ADDENDUM NUMBER TWO

This Addendum dated 4 September 2026 shall become a part of the original project documents for **BUILDING IMPROVEMENTS, Bldg. 3480**, Camp Gilbert C. Grafton, Devils Lake, North Dakota. Acknowledge receipt of this addendum on the Bid Form on BidExpress.com.

BUILDING IMPROVEMENTS

NDNG Project NO. 2621

A100

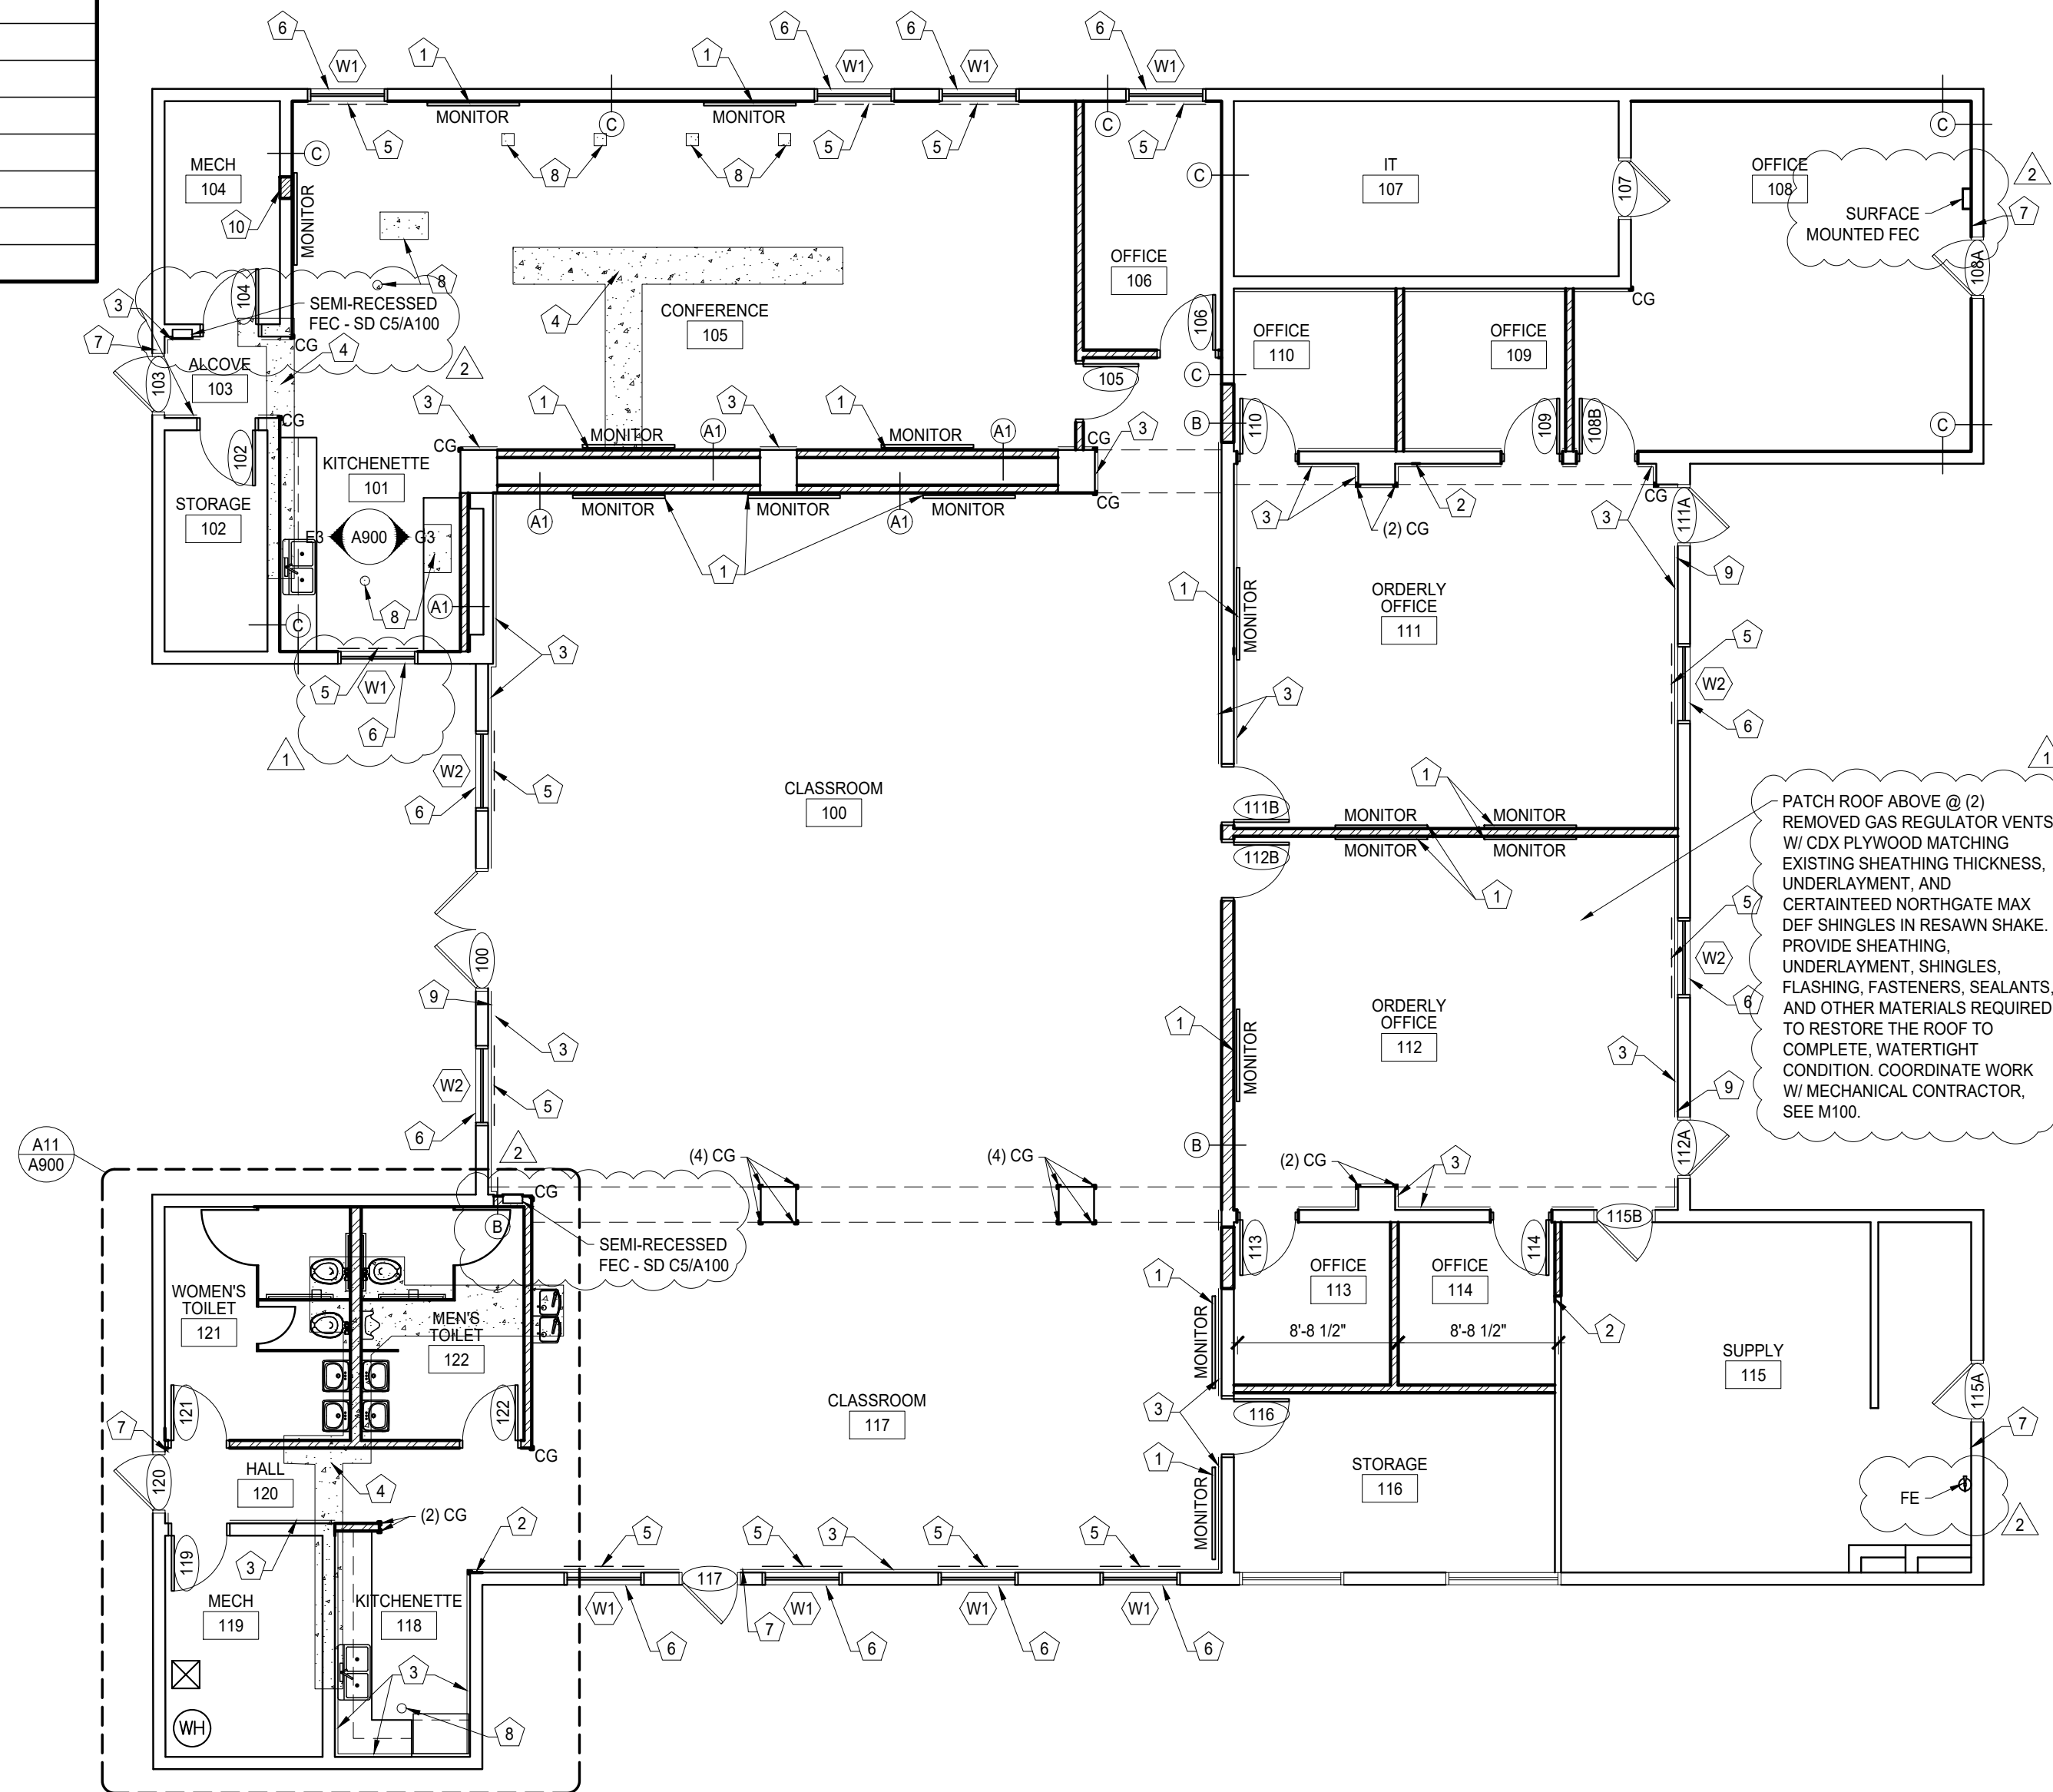
1. Sheet A100 – Main Level Floor Plan, Wall Types:

Replace Drawing Sheet A100, with the attached revised Sheet A100 (Attachment 1). Note locations of fire extinguishers and fire extinguisher cabinets added to the Main Level Floor Plan.
